EPA 542-R-13-006  
January 2013  
Office of Solid Waste and Emergency Response  
Office of Superfund Remediation and  
Technology Innovation

**Optimization Review**  
**Peck Iron and Metal Superfund Site**  
**Portsmouth, Virginia**

Report of the Optimization Review and  
Site Visit Conducted at the Peck Iron and Metal Superfund Site on  
February 22, 2012

January 18, 2013

**Figure 14**  
**Nickel Concentrations in Soils**  
**(0 to 18 inches bgs)**

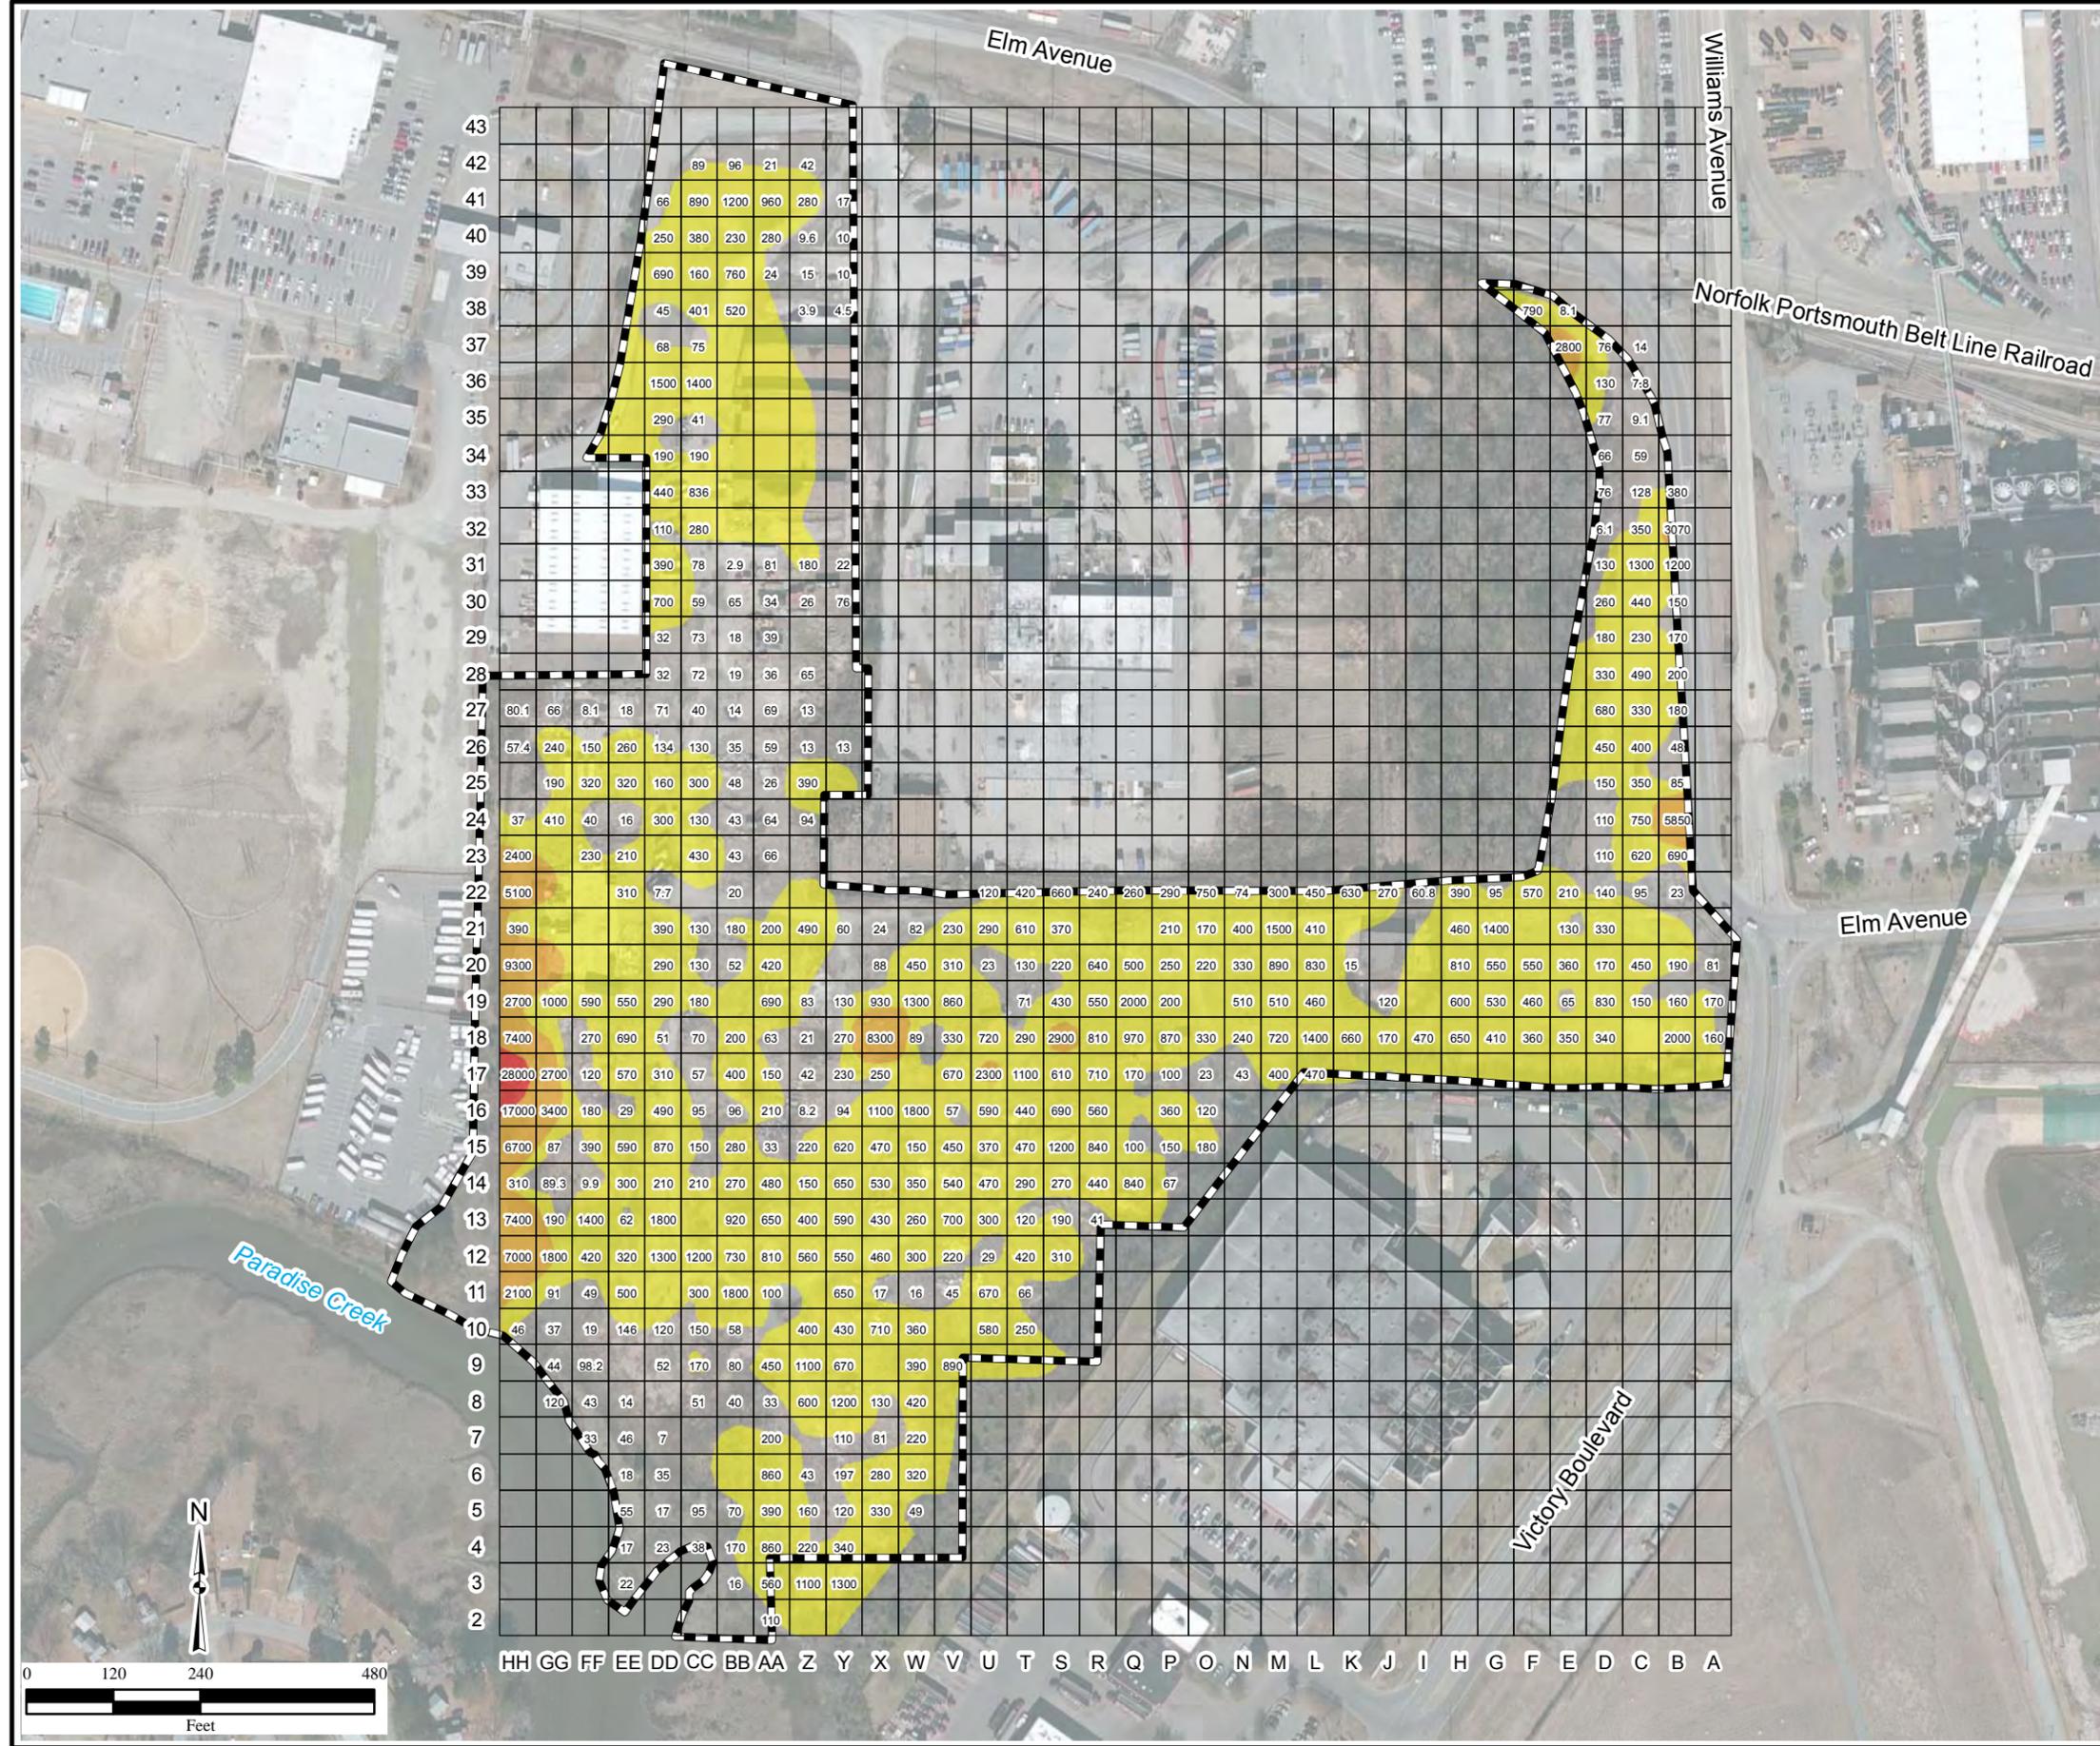
Figure 14 shows surface soil concentrations for nickel. Yellow, gold and red shaded grid cells encompass Site areas that exceed 150 mg/kg and thus define areas in which nickel concentrations exceed the screening level of 38 mg/kg. Review of the non-shaded areas (mercury concentrations below 0.1 mg/kg) reveals that with some exceptions, most non-shaded grid blocks also exceed the nickel screening level. The principal areas of non-exceedance include the southwestern portion of the Site (between rows 3–8 and columns DD–FF), south of the block of masonry buildings in the northwestern portion of the Site (between rows 26–31 and columns Y–BB) and in the northwestern corner of the Site (between rows 38–42 and columns Y–AA).

**Figure 15**  
**Silver Concentrations in Soils**  
**(0 to 18 inches bgs)**

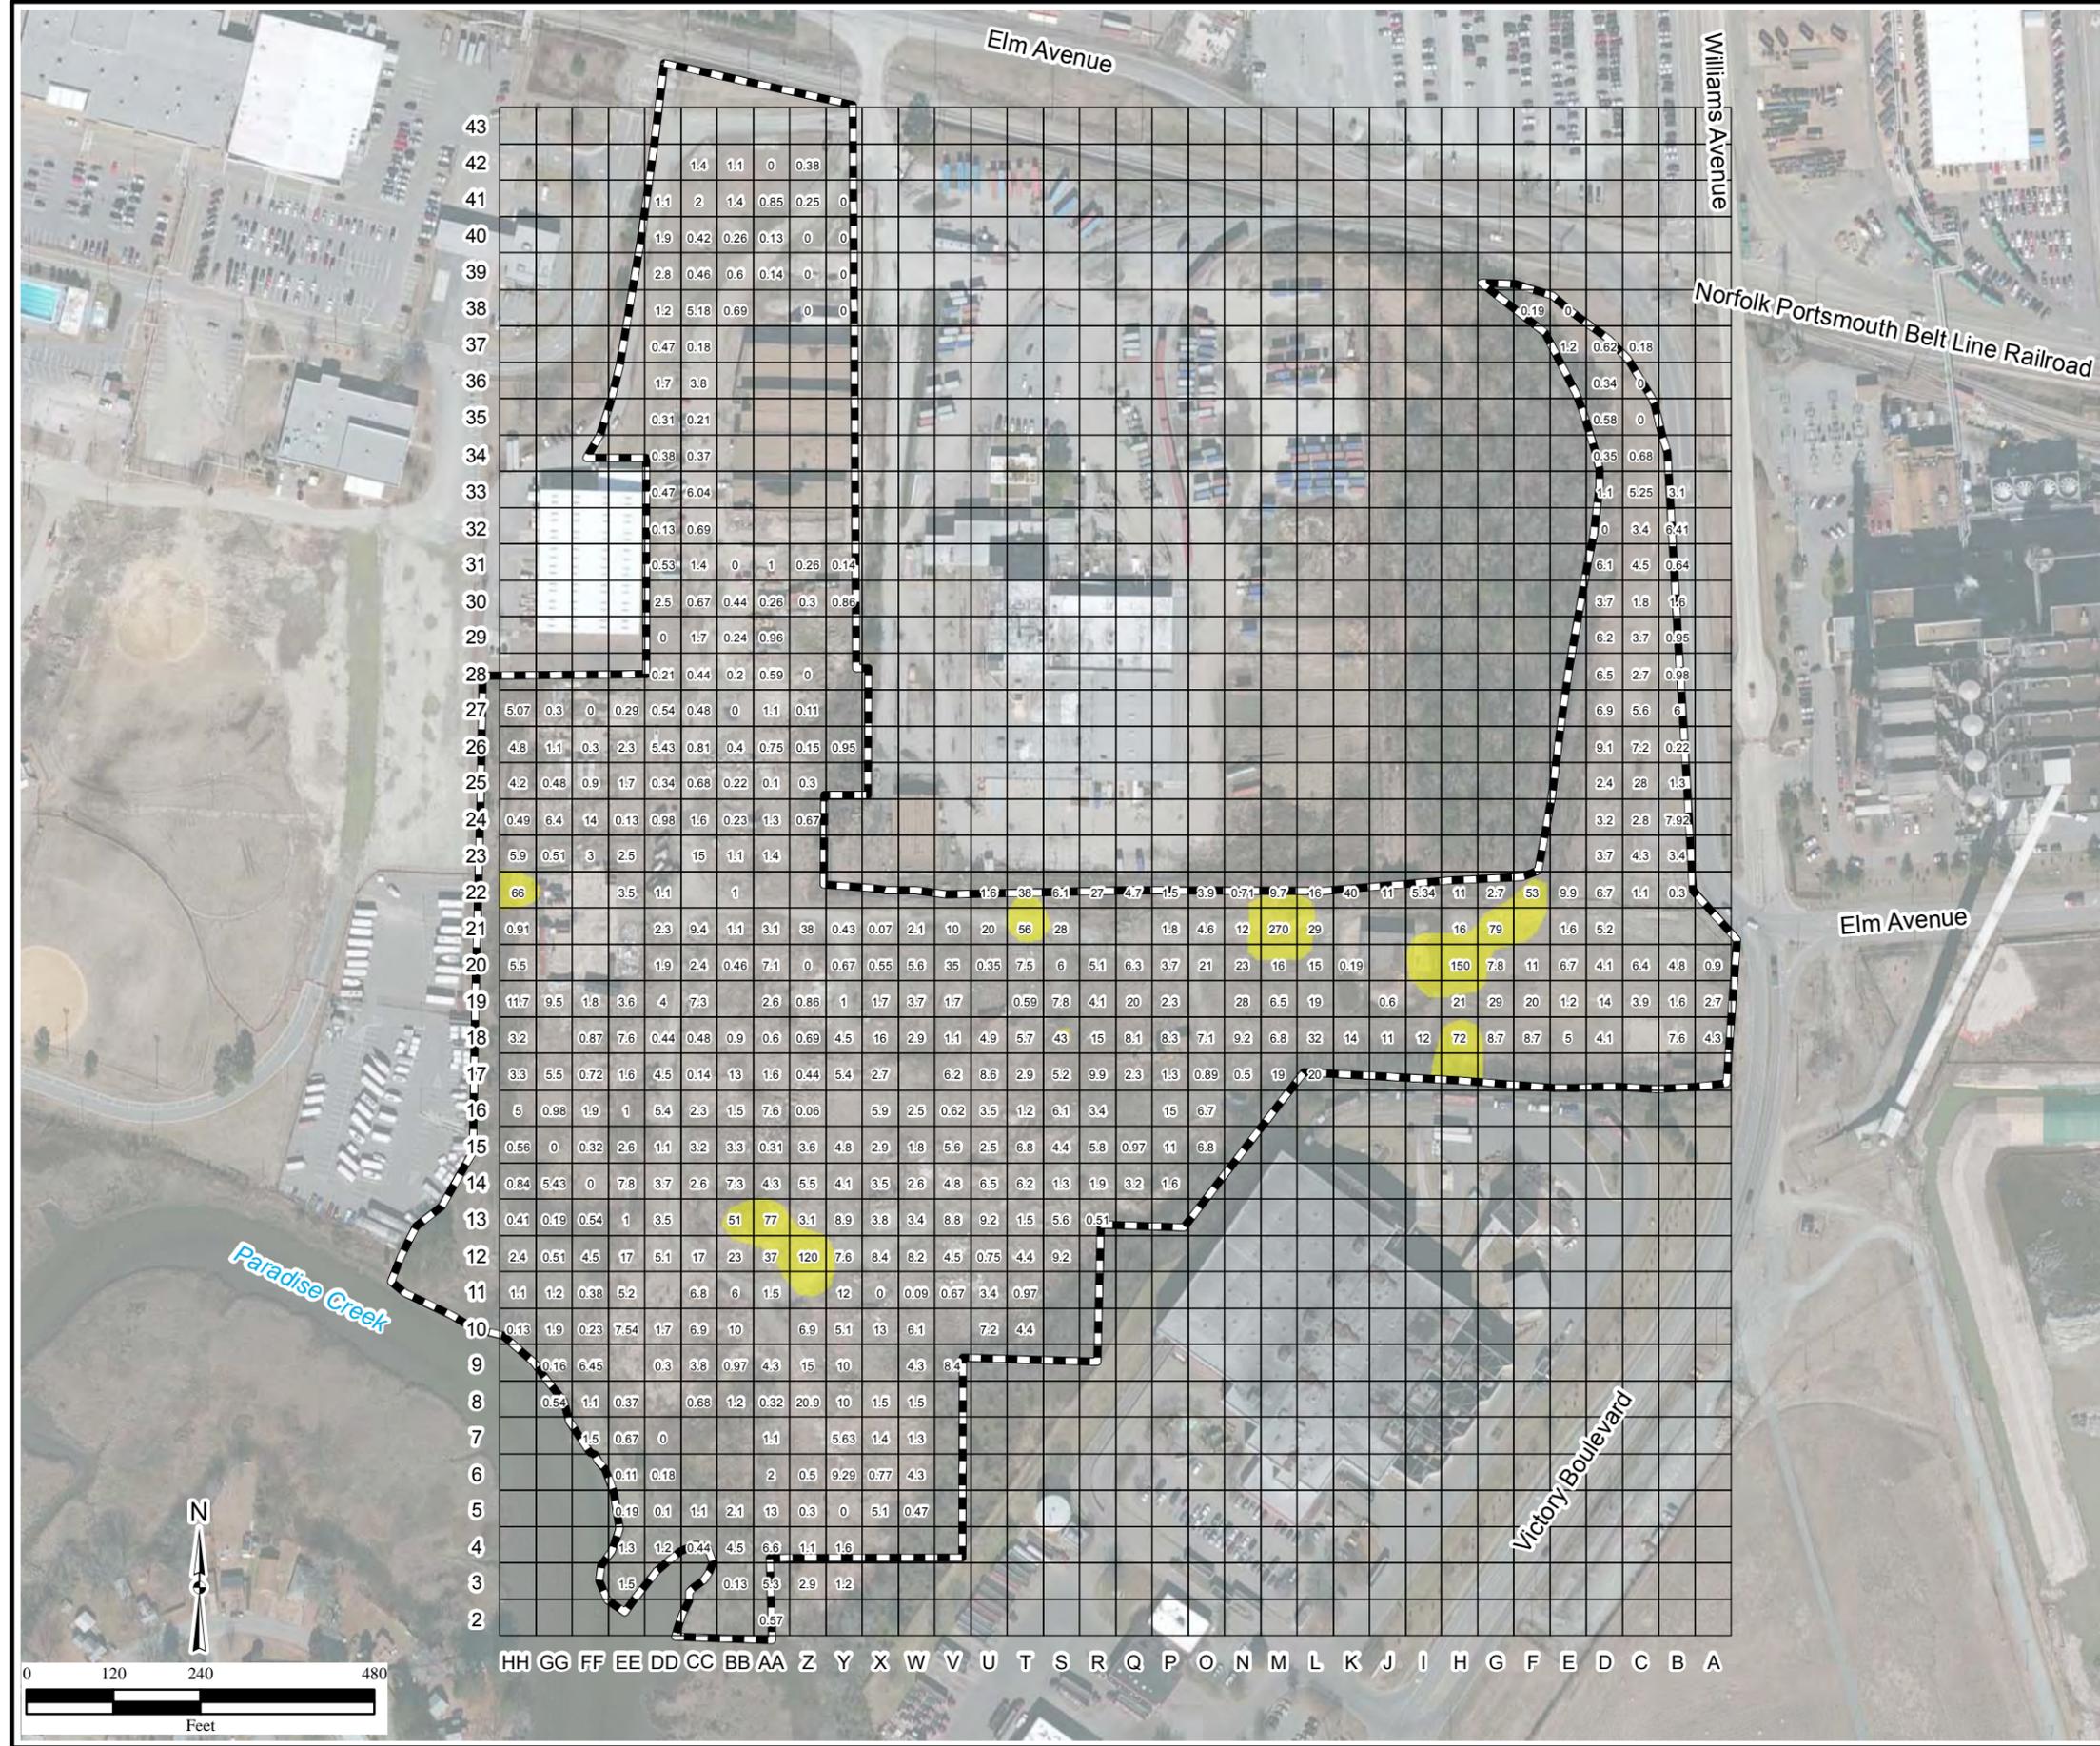
Figure 15 shows surface soil concentrations for silver. Because the minimum contour defines silver concentrations of 39 mg/kg or greater (compared to a screening level of 4.2 mg/kg), all shaded areas shown on the figure exceed the silver screening level. In addition, large areas of unshaded cells also exceed the screening level including cells in the northeastern portion of the Site (between rows 25 to 33 and columns B–E), in the central and eastern portion of the Site (between rows 13 and 22 and columns A through V) and in the southern portion of the Site (between rows 2 and 13 and columns X through EE).

**Figure 19. Optimization Team-Proposed Soil Investigation Decision Logic (Offsite Contamination and Hot Spot Assessment)**

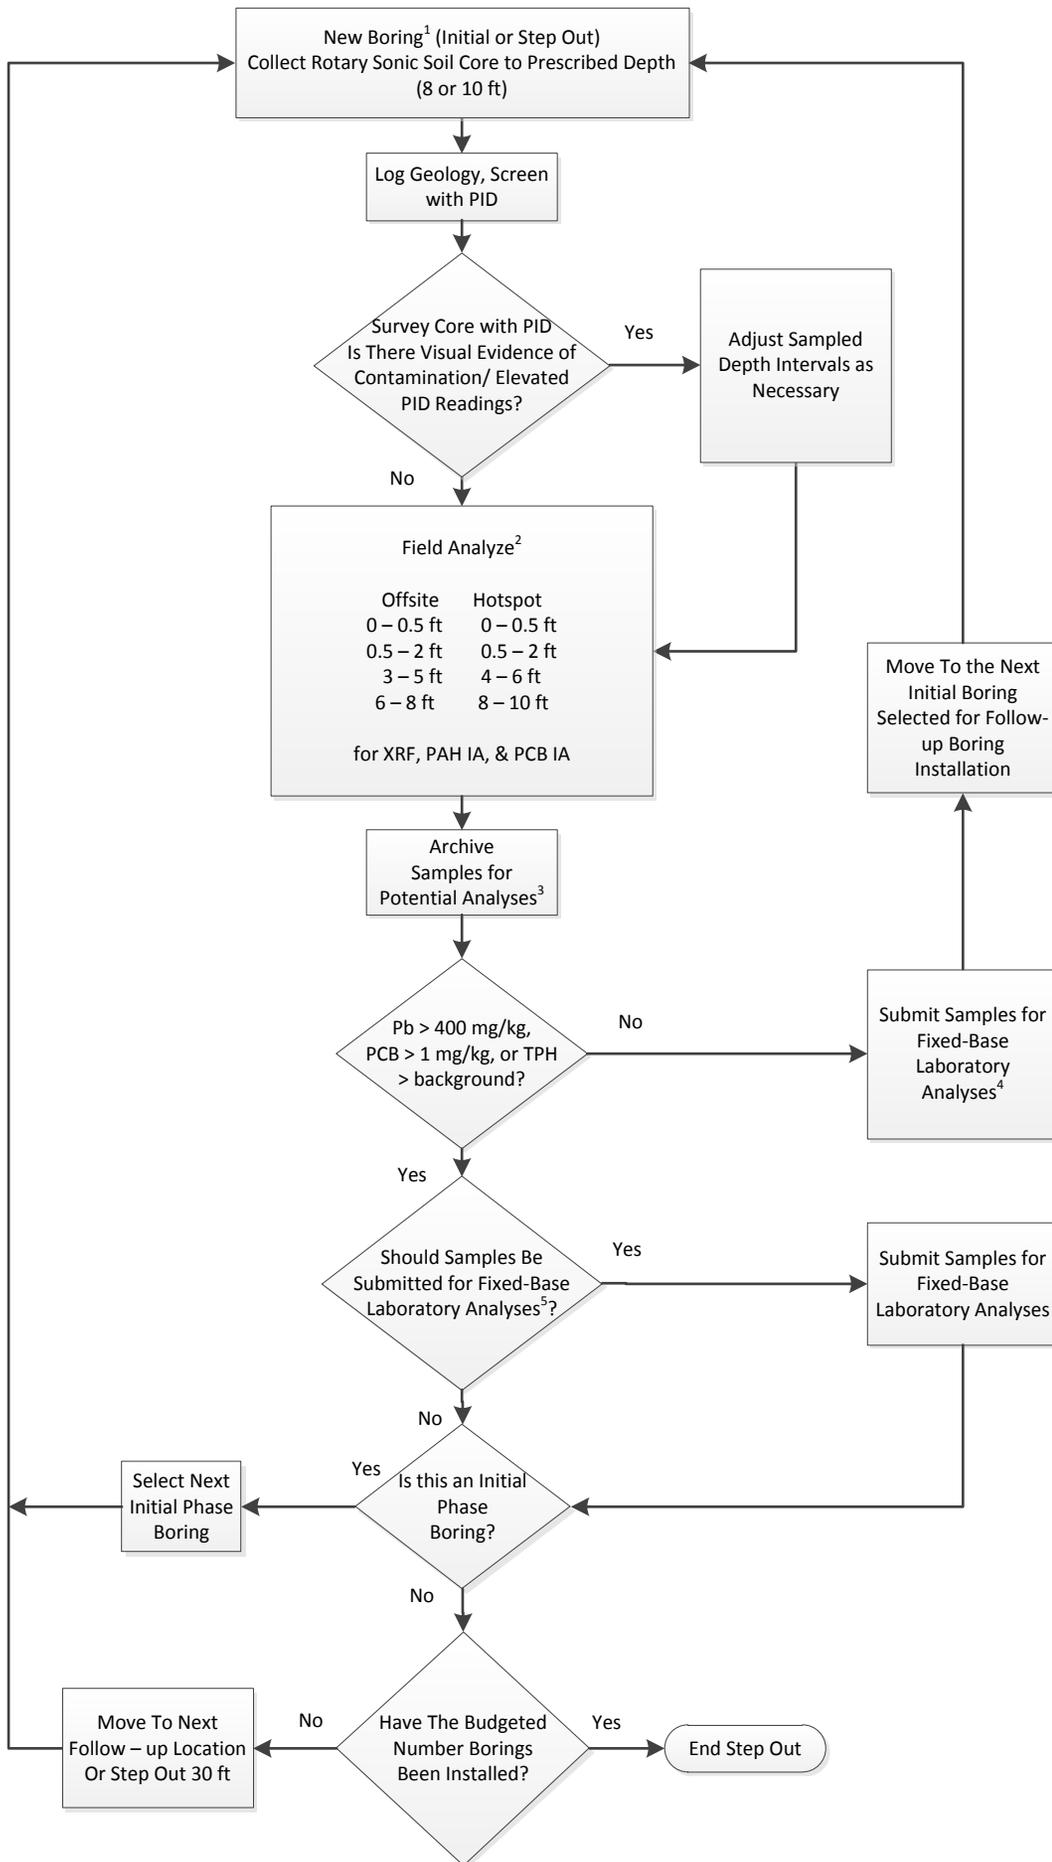
The specific approach is described below and shown on Figure 19 in flow-diagram format. At the HGL plan-prescribed 23 offsite and 31 hotspot locations, install soil borings and collect soil samples at the plan-defined depth intervals. Each of the soil samples collected is then analyzed via PID, XRF, PAH IA and PCB IA and is archived. Based on an evaluation of the field analysis data from the initial borings, select a percentage (20 percent) of the soil samples for fixed-base laboratory analysis and a subset of the initial boring locations (3 to 5) for follow-up step out boring installation. Identify the optimal number of adaptive step out borings that can be installed given project budgetary constraints. Install the step out borings with the goal of placing at least one boring per each of the 3 to 5 follow-up locations. Screen cores and field analyze over the required sampling intervals used for the initial borings. Archive all samples from the prescribed sampling depths. Select for submission for fixed-base laboratory analysis all samples from the final step out boring associated with each initial phase boring.
